**Addendum No. 1**  
**February 15, 2017**

Project: Brandon Valley Middle School Office Addition & Remodel  
Brandon, South Dakota

Project No.: 2700

**BVMS OFFICE ADDITION & REMODEL  
SITE PLAN - DEMOLITION**

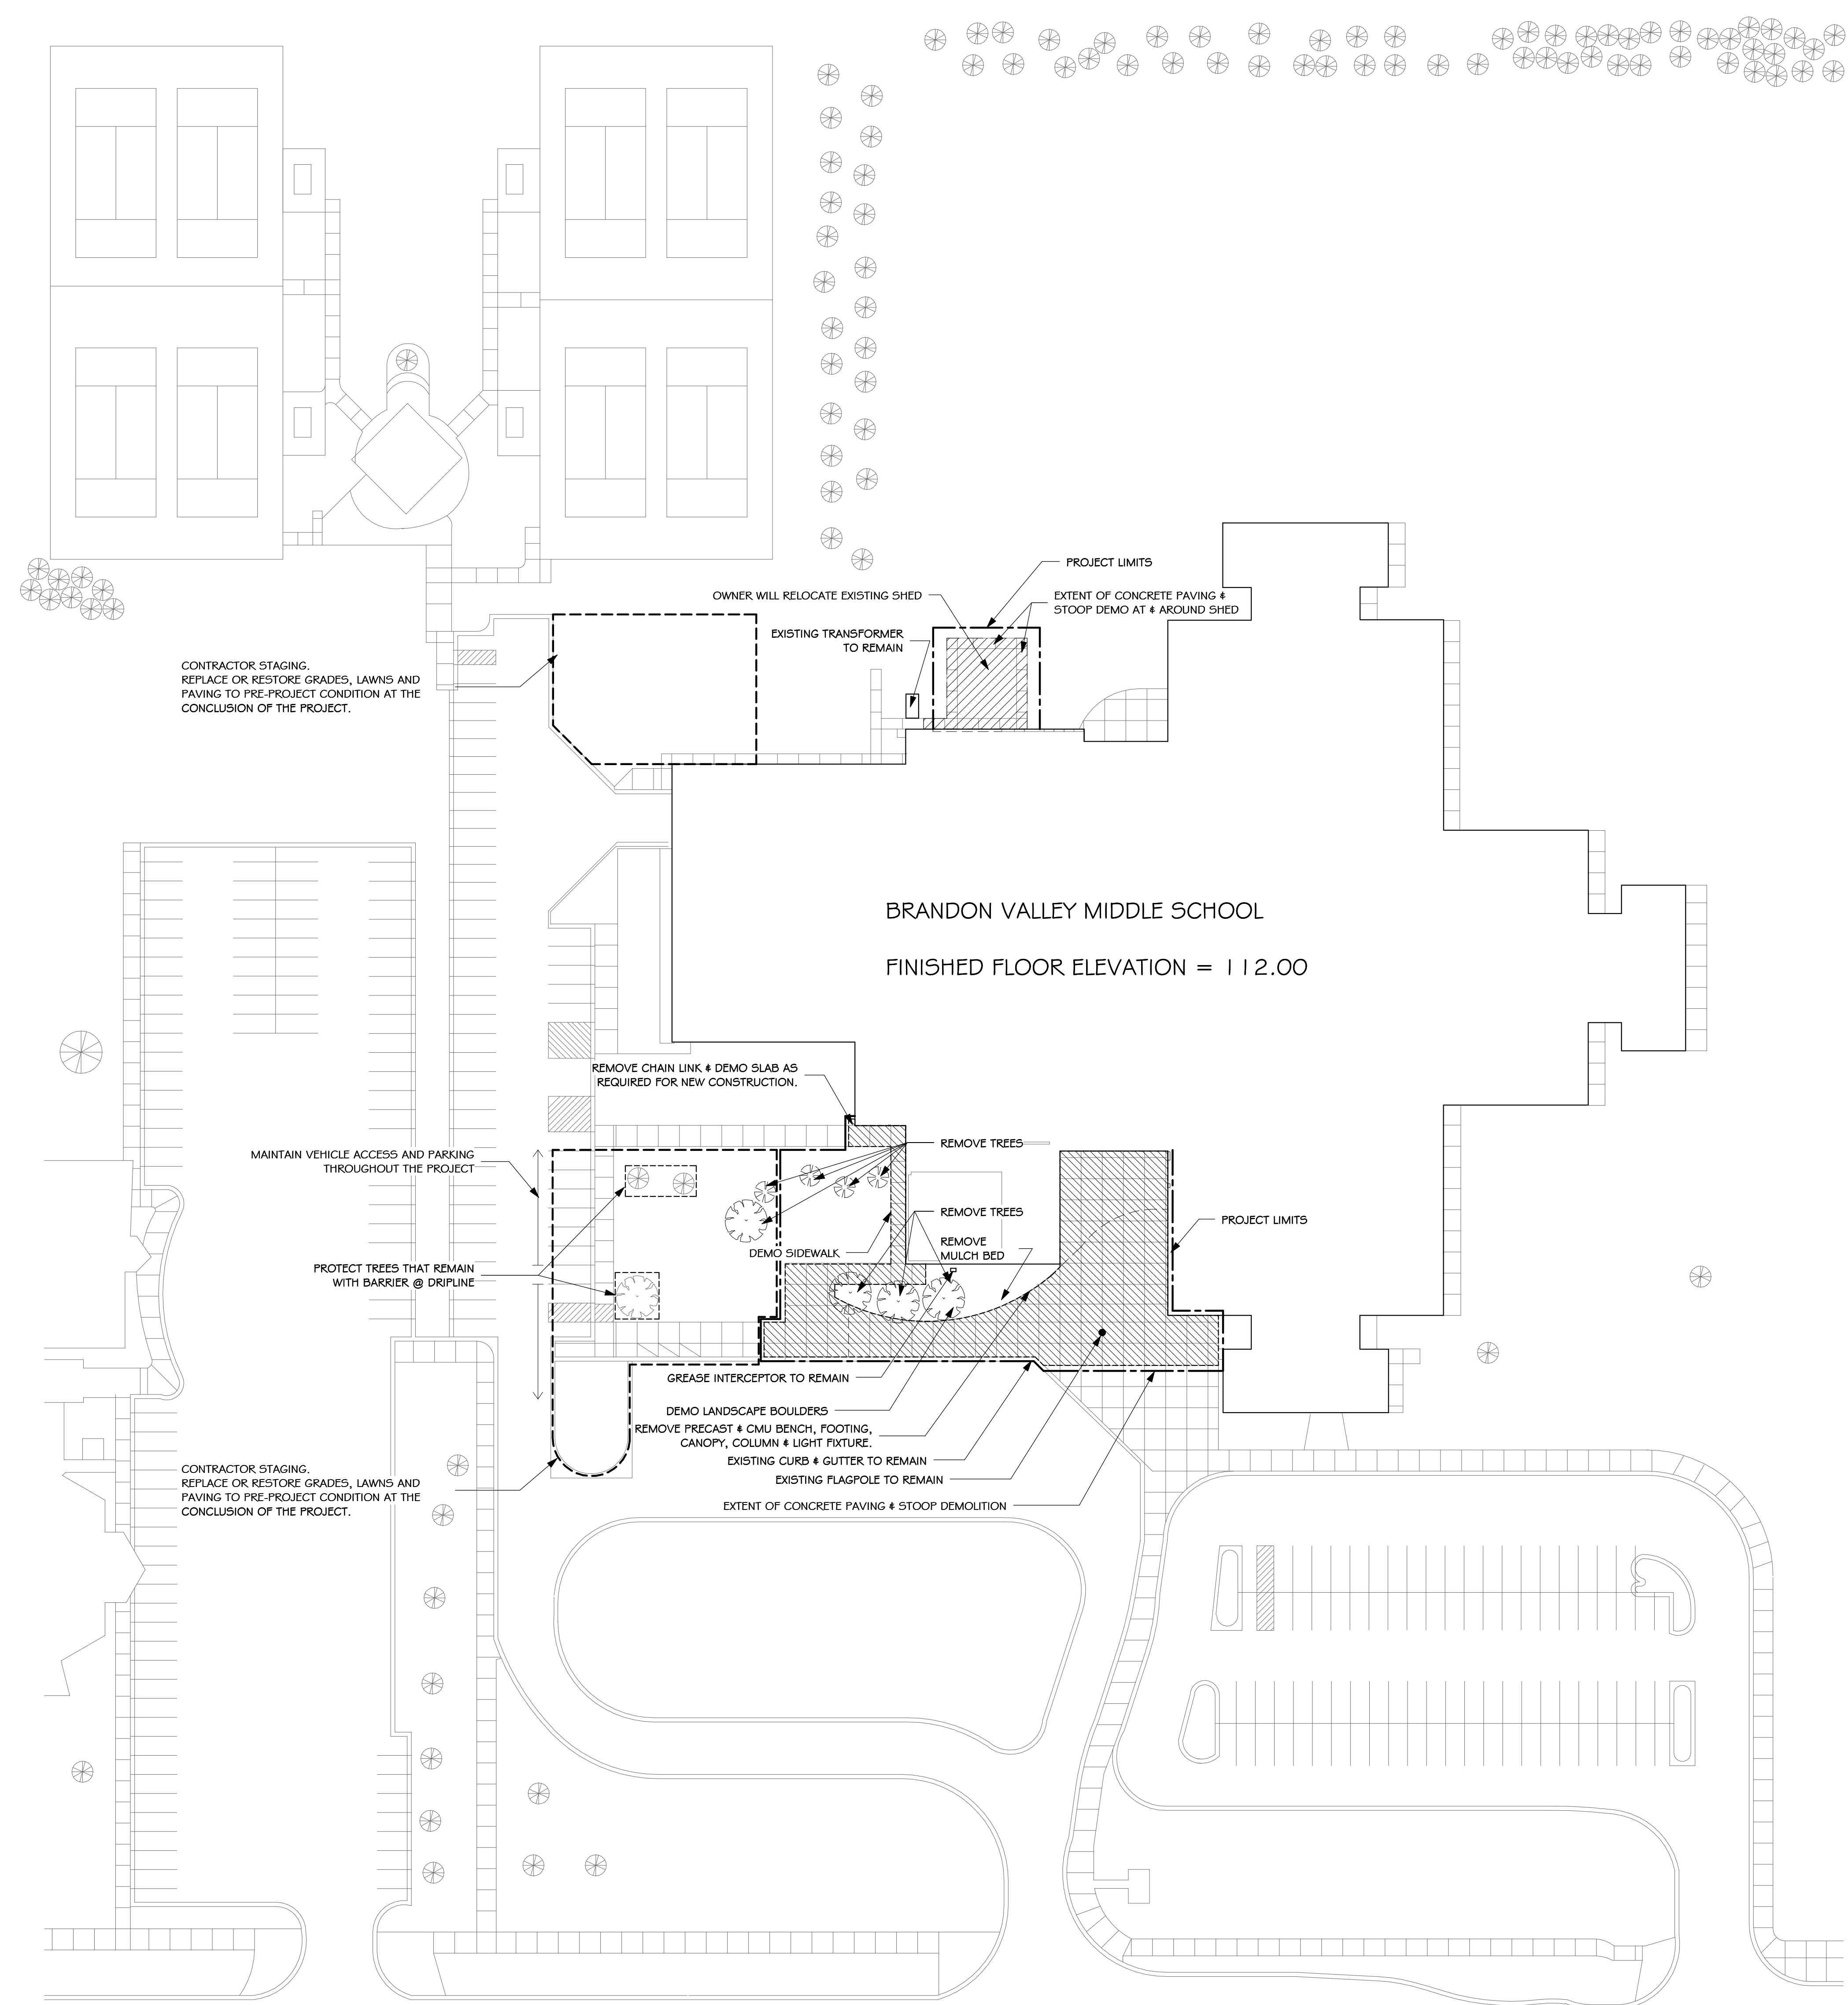
- 5) DRAWING SHEET 2.20
  - a) Refer to Drawing Sheet 2.20 Site Plan – Demolition, attached to the end of this addendum.
- 6) DRAWING SHEETS 3.2-1 AND 3.2-2

**A** PARTIAL 121 - SOUTH ELEVATION  
 SD-1 SCALE: 1/4" = 1'-0" (AT ENTRANCE TO BOYS 102 & GIRLS 104)

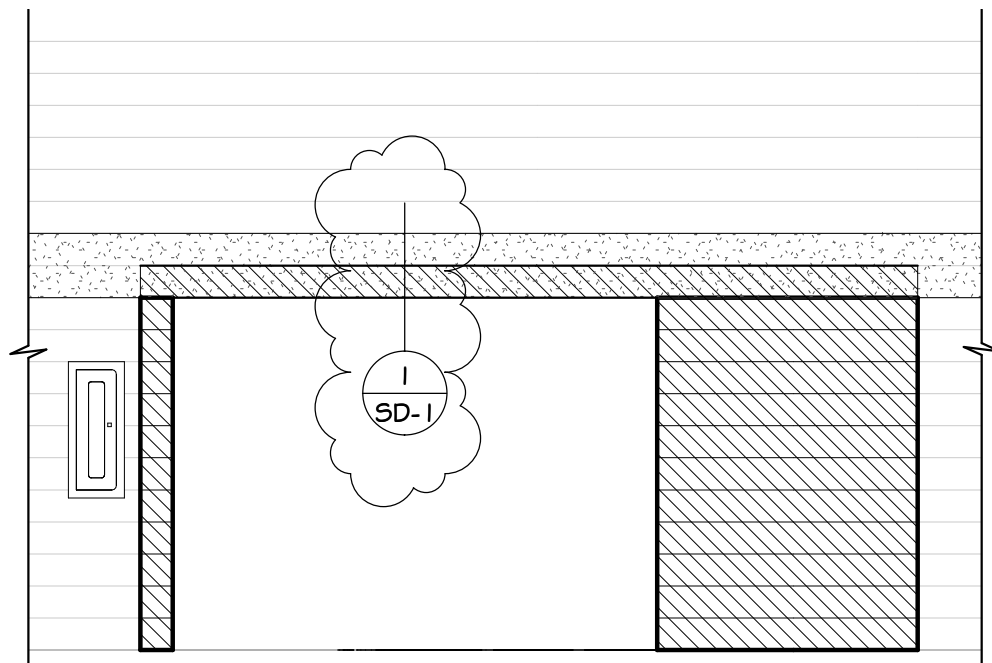
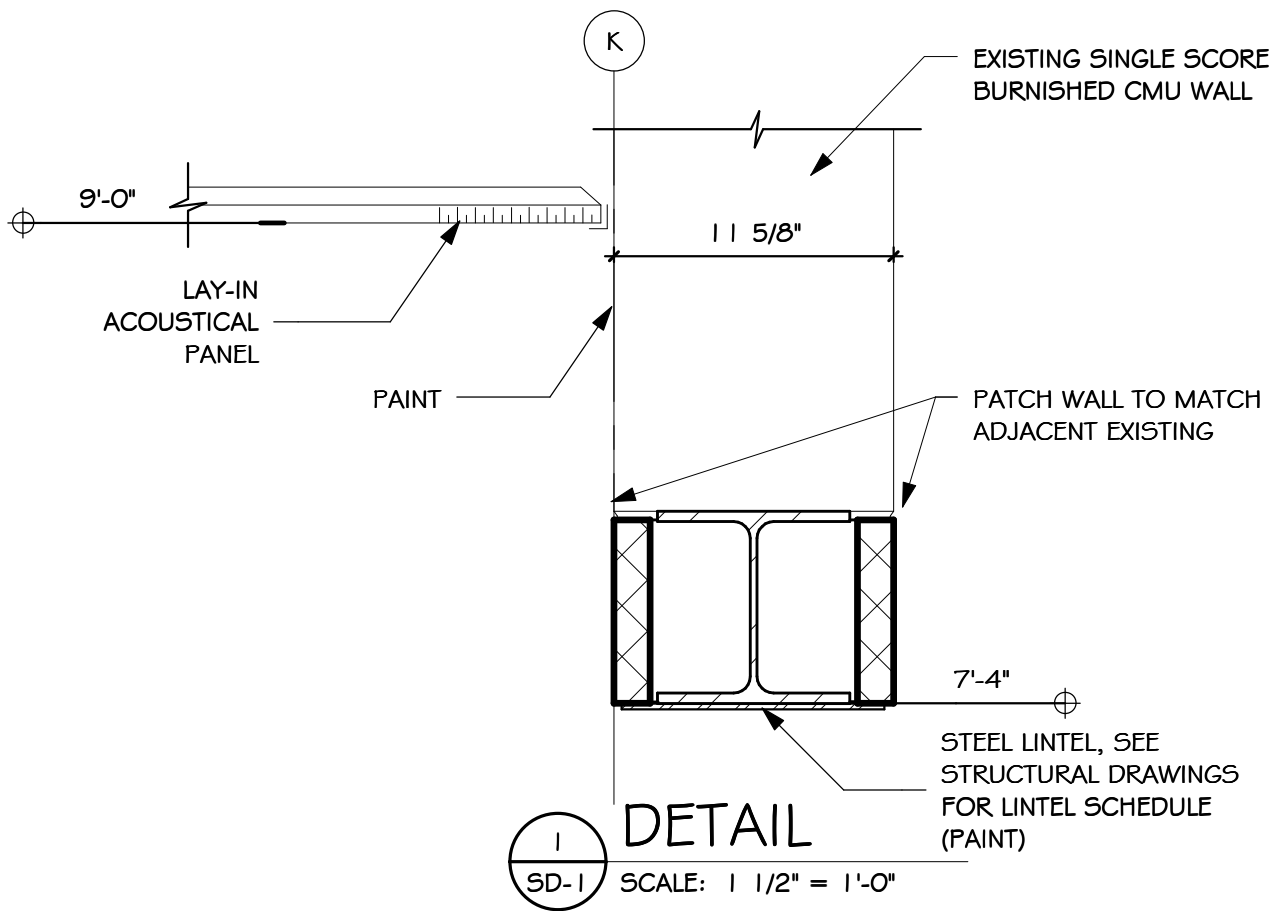
- a) Detail A/4.50 – refer to Supplemental Drawing SD-1, attached to the end of this addendum, for lintel detail at entry to Boys 102 & Girls 104.
- 12) DRAWING SHEET 5.30

# PARTIAL REFLECTED CEILING PLAN - AREA A

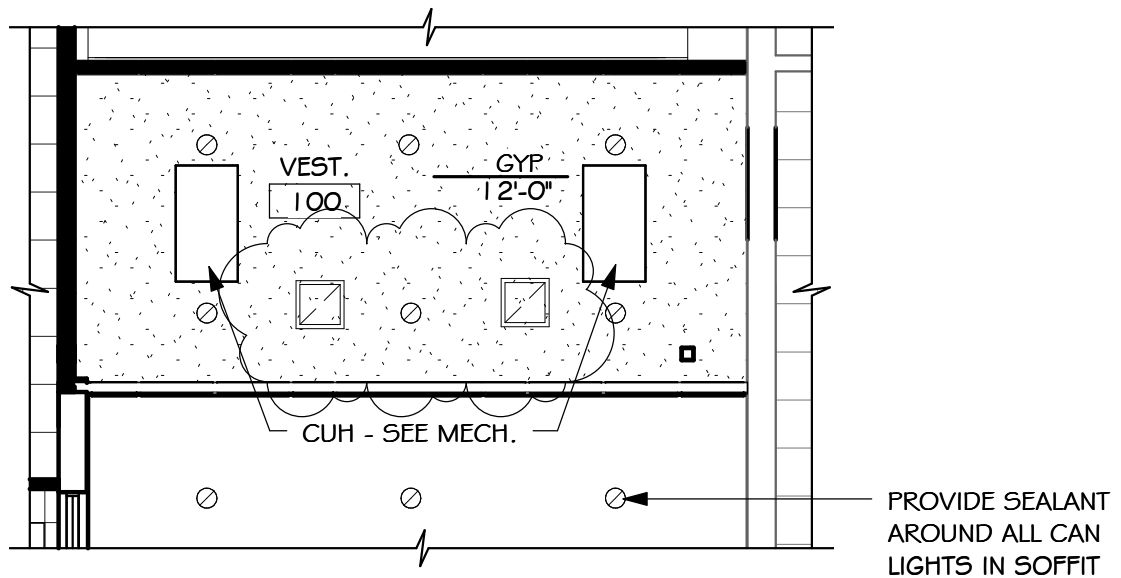
- a) Refer to Supplemental Drawing SD-7, attached to the end of this addendum, for revisions to Detail 1/5.51.
- 16) DRAWING SHEET 6.10
  - a) Refer to Supplemental Drawing SD-2, attached to the end of this addendum, for grille locations in ceiling at Vestibule 100.

SD-3 PARTIAL ROOF PLAN - AREA 'A'

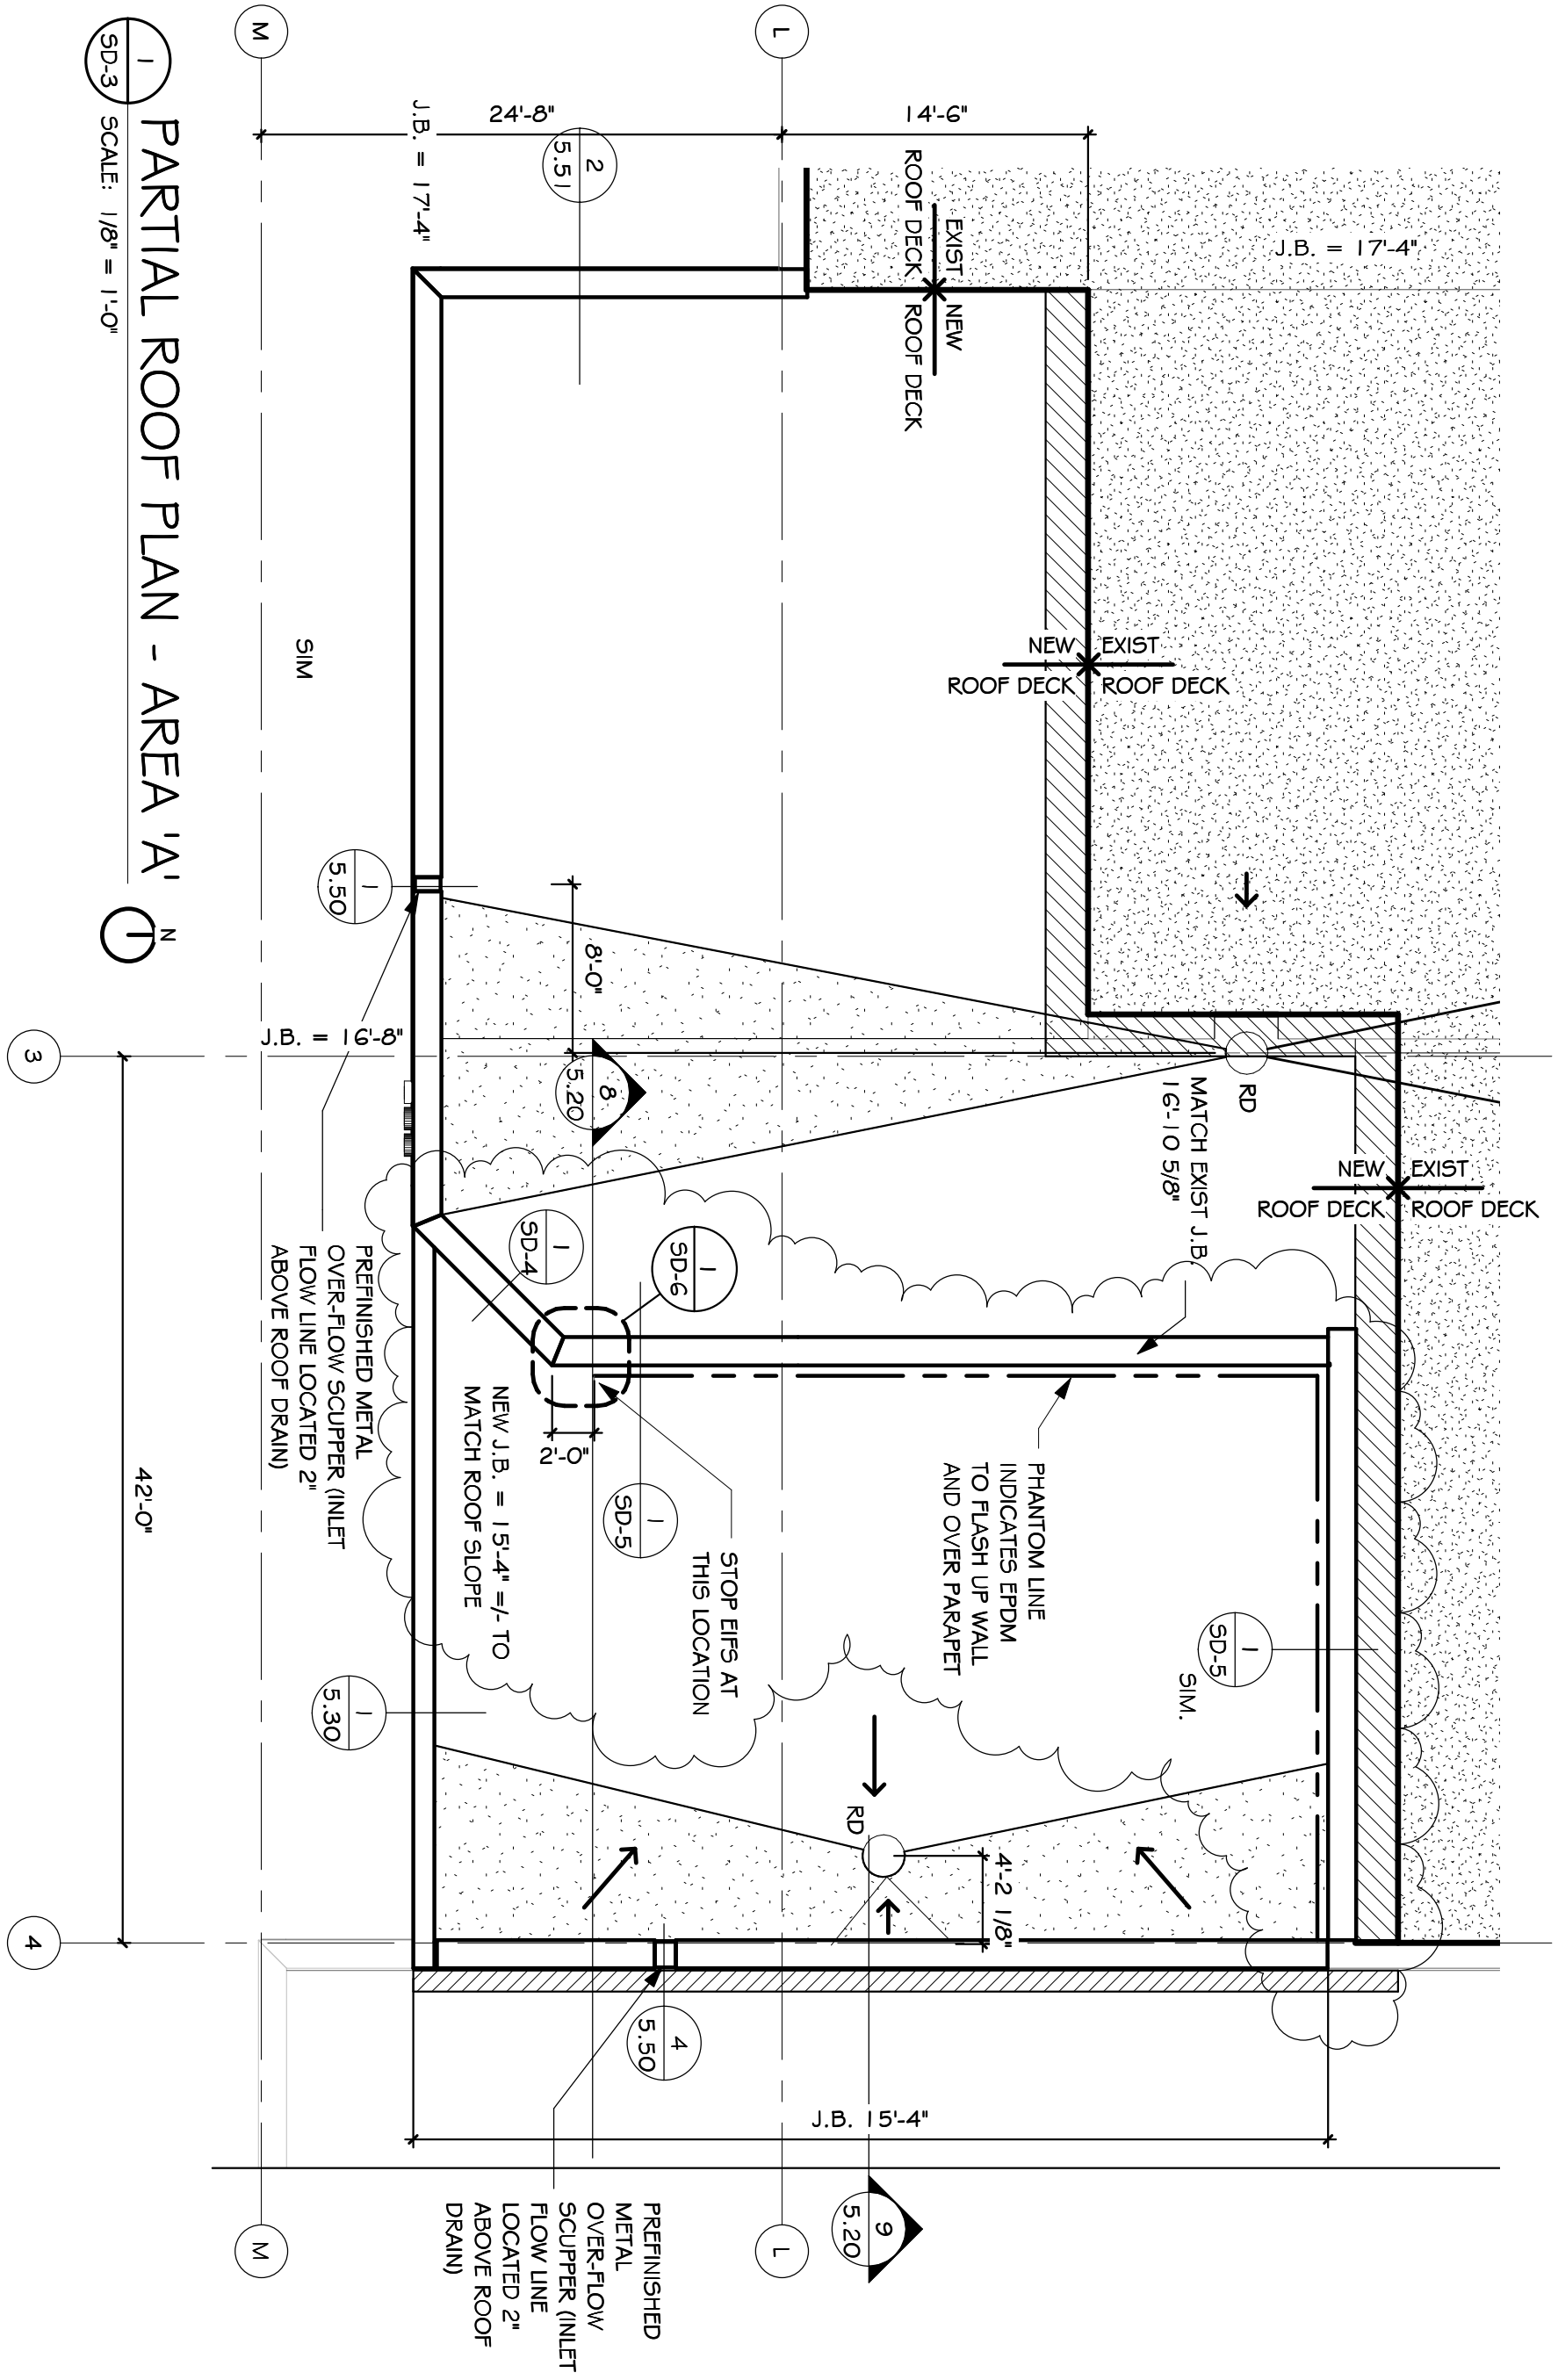
- ii) Refer to Supplemental Drawings SD-3 through SD-6, attached to the end of this addendum, for revisions to the low wall finish/roof transition at the roof above the canopy and Room 100.
